# Product Recall

- **FA-NM-ST Maretron Mini Field Attachable Connector (Male)**

Carling Technologies Reference: QAF-136\_05/17/2022, SCAR-0404-22

**FA-NM-ST**

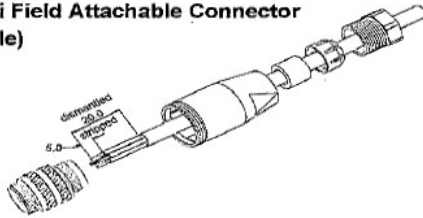
Reason: Label on the connectors were switched by label printing error. This causes customer installation of the power port to communication port which leads to communication and power failure.

Corrective Action: Please validate the labeling of your connector matches the correct pinout below. If your connector does not match the following setup, please request an RMA by contacting our support team or via our RMA portal.

- 1: SHIELD (DRAIN)
- 2: NET-S (+ VOLTAGE)
- 3: NET-C (- VOLTAGE)
- 4: NET-H (CAN\_H)
- 5: NET-L (CAN\_L)
